S4.55(1A) MODIFICATION REPORT

Doncaster Ave, Kensington

Prepared for
COR PARTNERS
30 August 2021

Figure 1 Approved and proposed cluster rooms

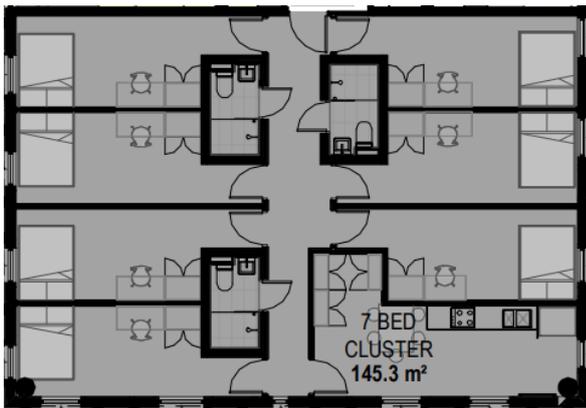
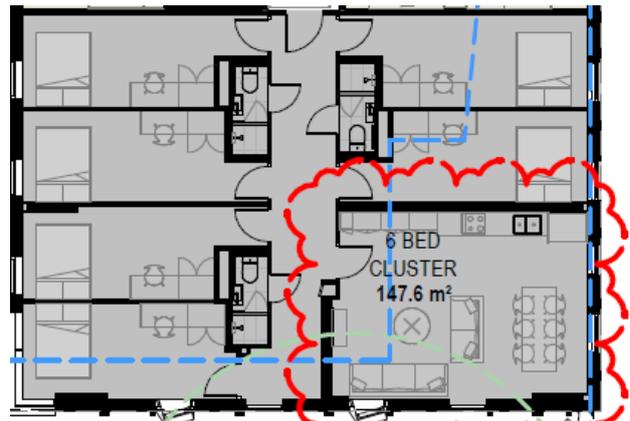
- **Redesign of the five 7 bed clusters into 6 bed clusters**

It is proposed to reconfigure the five approved seven bed clusters into six bed clusters. The proposed modification to the design will reduce the total number of students on site from 259 to 254 and provide a larger common area within the clusters as shown in **Figure 1**.
